Access Compliance Report

Public Rights-of-Way

Intersection ID: 13871	Main Street: E_5TH_ST	Cross Street: HAWTHORNE_LN	Location: W
ADA ID: AB3715A260EC	Ramp Type: BlendTrans1	Initial Pass/Fail: Pass	Overall Compliance: No
		Severity Score: 0	
Codes/Mitigation Info/Possible Solution		Field Measurements/Component Compliance

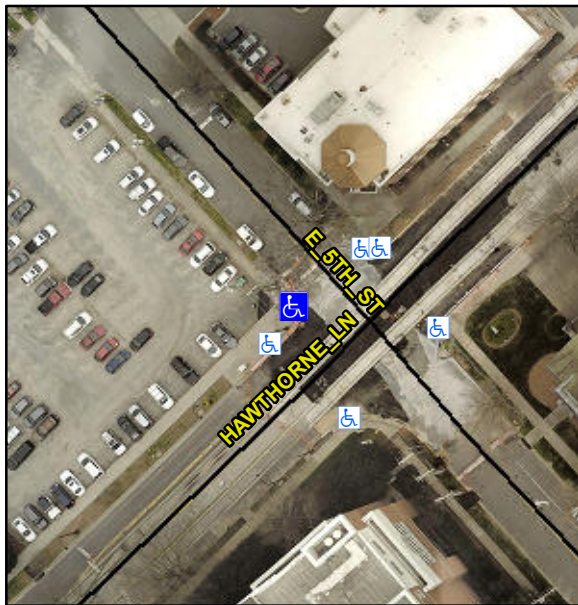
Remove & Replace Curb Slope and Extend Ramp. Remove & Replace Gutter.

Not Found, R304.5.3

Yes	Ramp inside XWalk1?	Yes	N/A	Ramp inside XWalk2?	N/A
	Road Slope (%)	3.0		Clear Space?	Yes
	Road X Slope (%)	0.7	N/A	Clear Space to XWalk (in)	N/A
Yes	Any Obstructions?	No	Yes	Storm Grate/Utility Hazard?	No
	Obstruction Type			Storm Grate/Utility Type	
		N/A			N/A
			Yes	Surface Condition? (G/P)	Good
			No	Curb Slope (%)	16.4
